Access Compliance Report

Public Rights-of-Way

(Curb Ramps)

Intersection ID: 32114	Main Street: DUNDALK_RD	Cross Street: WILSON_DR	Location:	E
ADA ID: BC58D7F723B3	Ramp Type: Perp	Initial Pass/Fail: Fail	Overall Compliance: No	Severity Score: 1.25
Codes/Mitigation Info/Possible Solution		Field Measurements/Component Compliance

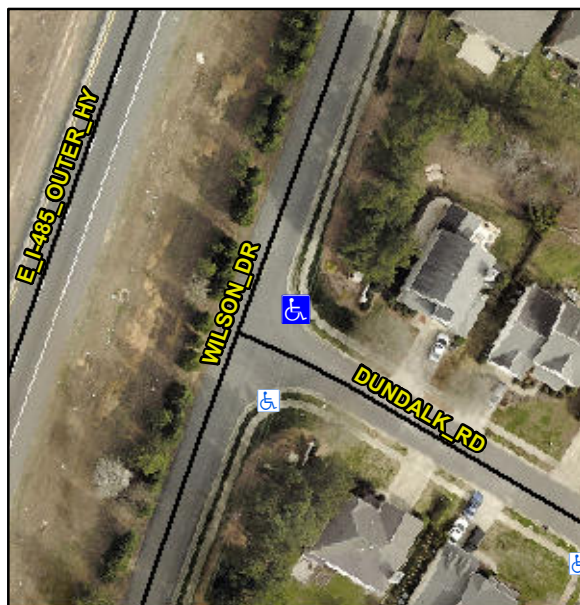
Not Found, R304.5.3

Compliance	Description	Data	Compliance	Description	Data
N/A	Ramp Length (in)	45.5	Yes	Ramp Slope (%)	5.3
Yes	Ramp Width (in)	56.5	No	Ramp XSlope (%)	4.0
N/A	Flare Type LT	N/A	N/A	Flare Type RT	N/A
N/A	Flare Slope LT (%)	N/A	N/A	Flare Slope RT (%)	N/A
N/A	Flare Traversable LT?	N/A	N/A	Flare Traversable RT?	N/A
N/A	Landing Length (in)	N/A	N/A	DWS Provided?	N/A
N/A	Landing Width (in)	N/A	N/A	DWS Contrast?	N/A
N/A	Landing Slope (%)	N/A	N/A	DWS Length (in)	N/A
N/A	Landing X Slope (%)	N/A	N/A	DWS Full Width?	N/A
N/A	Landing Curb? (Y/N)	N/A	N/A	DWS Offset (in)	N/A
N/A	Shared Landing?	N/A			
N/A	Gutter Ponding?	N/A	N/A	Gutter Slope (%)	N/A
N/A	Gutter Lip Ht (in)	N/A	N/A	Gutter X Slope (%)	N/A
N/A	Painted X Walk1?	No	N/A	Painted X Walk2?	N/A
	X Walk 1 Direction	To SW		X Walk 2 Direction	N/A
N/A	X Walk 1 Width (in)	N/A	N/A	X Walk 2 Width (in)	N/A
	X Walk 1 Slope (%)	0.6		X Walk 2 Slope (%)	N/A
	X Walk 1 X Slope (%)	6.0		X Walk 2 X Slope (%)	N/A

Remove & Replace Entire Ramp.
